**DESIGN AND BUILD CONSTRUCTION WORKS OF PROPOSED
FEMALE STUDENT ACCOMMODATION AT SOUTHERN
CAMPUS, SOORIYAWEWA
CONTRACT NO: RP/SOU/002/2021**

CLARIFICATION – RP/SOU/002/2021–C1

ADDENDUM – RP/SOU/002/2021–A1

Minutes of the Pre-bid Meeting					
Title of the Procurement		Proposed Male & Female Accommodation Building for Southern Campus, Sooriyawewa			
Time.	1000h to 1230h	Date	12 th January 2022	Location	Southern Campus, KDU
Attendees					
Officials from KDU

Annexure A: Hybrid Bed

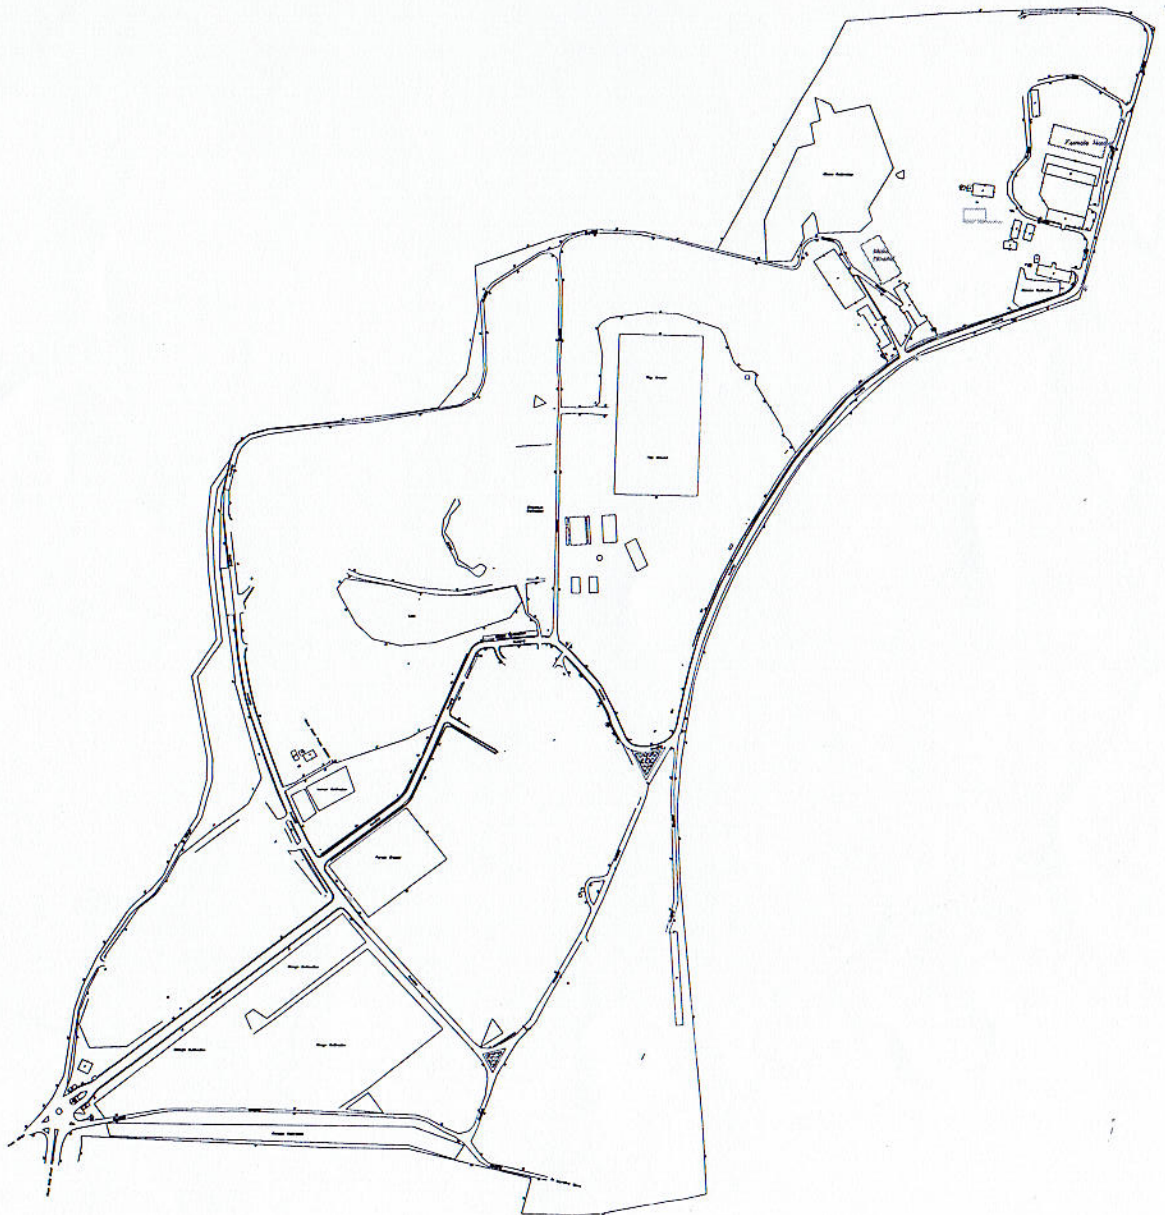
1.02	Chapter 03 Employer's Work Package, Page 36	Demonstration of Hybrid Bed	Pictures of the proposed Hybrid Bed is attached as Annexure A.
1.03	Chapter 04 Overall Scope of Work, Page 38	Ground clearance requirement on site.	Trees on the Male Hostel site will be removed by client. Ground clearance on the Female Hostel site including excavation is to be concluded by the D&B Contractor if deemed necessary.
